SUNDANCE RANCH - INDIVIDUAL

SITE PLAN INDIVIDUAL COMBINED CONCEPT 1

AUGUST 20, 2021

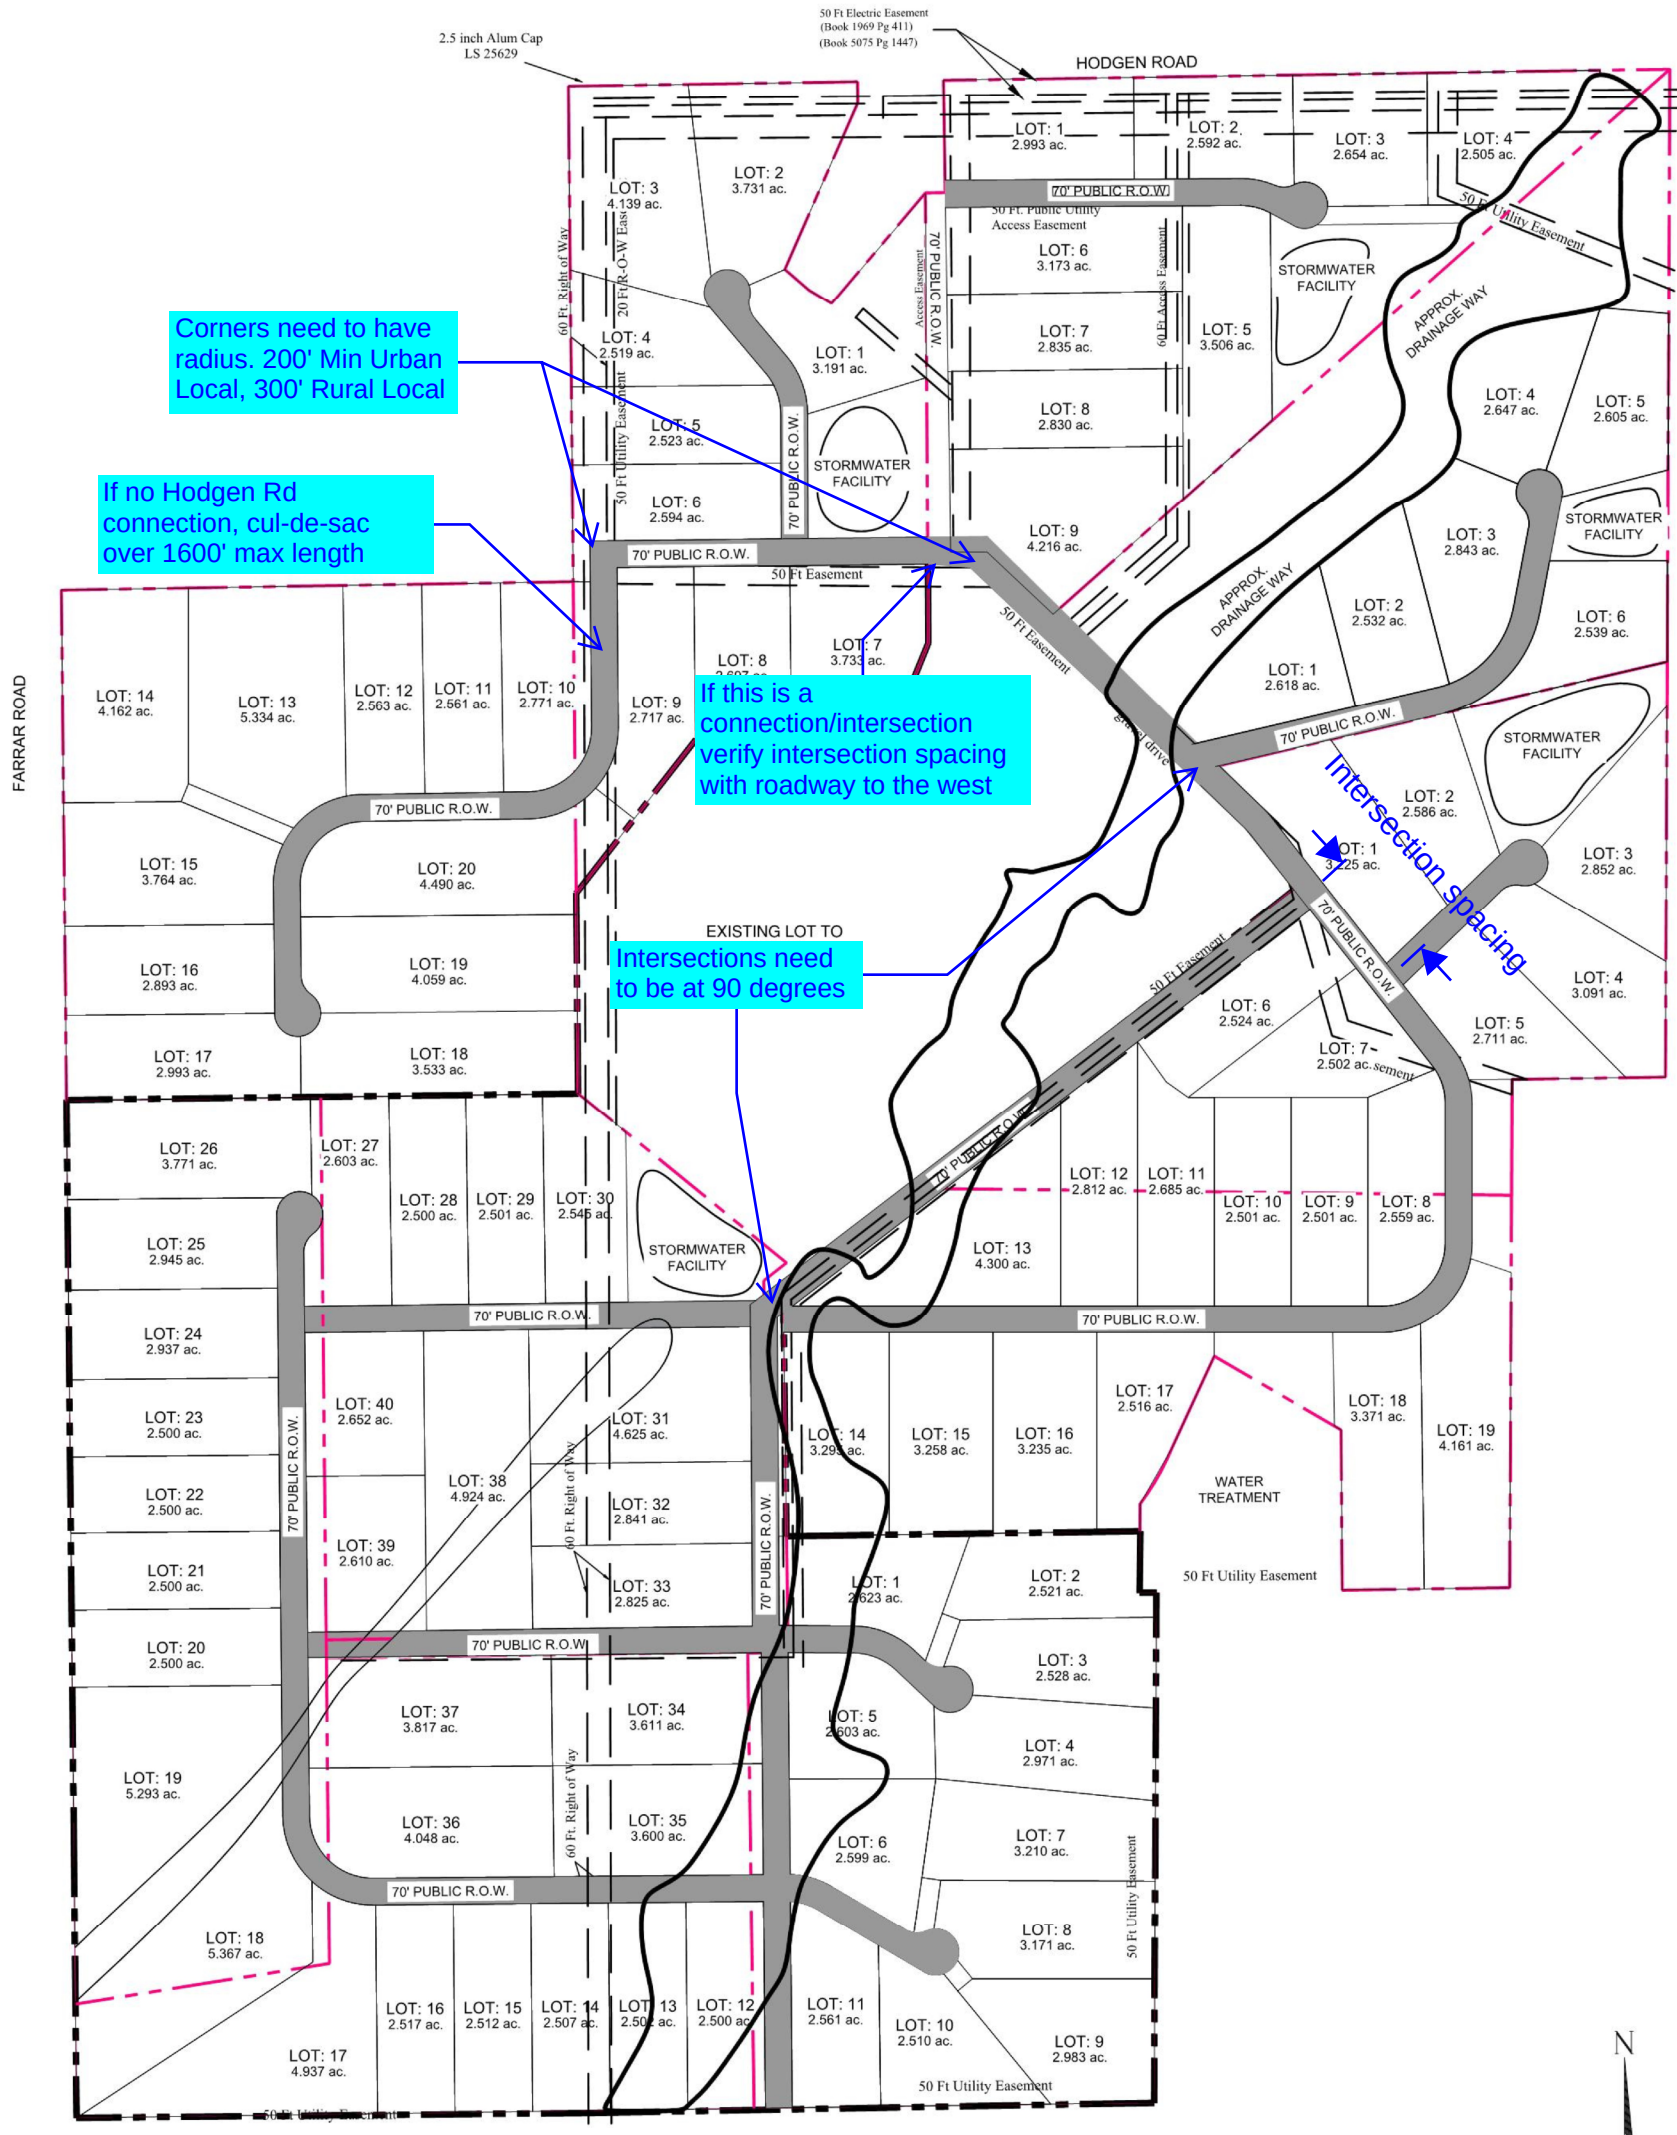
2nd connection to outside roadway system

Corners need to have radius. 200' Min Urban Local, 300' Rural Local

If no Hodgen Rd connection, cul-de-sac over 1600' max length

If this is a connection/intersection verify intersection spacing with roadway to the west

Intersections need to be at 90 degrees

Intersection spacing
